Access Compliance Report

Public Rights-of-Way (Curb Ramps)

Intersection ID: 31171	Main Street: POINTER_RD	Cross Street: BROWNE_RD	Location: NE
ADA ID: 84EFE6591ADD	Ramp Type: Perp	Initial Pass/Fail: Fail	Overall Compliance: No
		Severity Score: 1.25

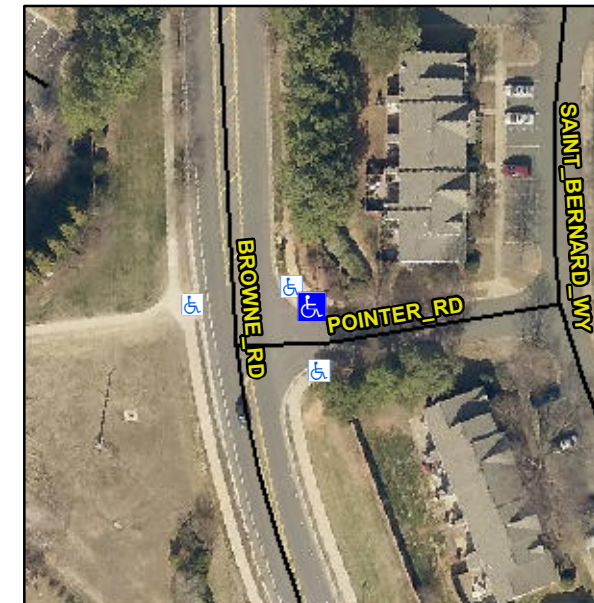
R304.5.3

Compliance	Description	Data	Compliance	Description	Data
N/A	Ramp Length (in)	60.0	Yes	Ramp Slope (%)	6.8
Yes	Ramp Width (in)	48.0	No	Ramp XSlope (%)	4.6
N/A	Flare Type LT	N/A	N/A	Flare Type RT	N/A
N/A	Flare Slope LT (%)	N/A	N/A	Flare Slope RT (%)	N/A
N/A	Flare Traversable LT?	N/A	N/A	Flare Traversable RT?	N/A
N/A	Landing Length (in)	N/A	N/A	DWS Provided?	N/A
N/A	Landing Width (in)	N/A	N/A	DWS Contrast?	N/A
N/A	Landing Slope (%)	N/A	N/A	DWS Length (in)	N/A
N/A	Landing X Slope (%)	N/A	N/A	DWS Full Width?	N/A
N/A	Landing Curb? (Y/N)	N/A	N/A	DWS Offset (in)	N/A
N/A	Shared Landing?	N/A			
N/A	Gutter Ponding?	N/A	N/A	Gutter Slope (%)	N/A
N/A	Gutter Lip Ht (in)	N/A	N/A	Gutter X Slope (%)	N/A
N/A	Painted X Walk1?	No	N/A	Painted X Walk2?	N/A
	X Walk 1 Direction	To S		X Walk 2 Direction	N/A
N/A	X Walk 1 Width (in)	N/A	N/A	X Walk 2 Width (in)	N/A
	X Walk 1 Slope (%)	4.1		X Walk 2 Slope (%)	N/A
	X Walk 1 X Slope (%)	4.9		X Walk 2 X Slope (%)	N/A

Remove & Replace Entire Ramp.
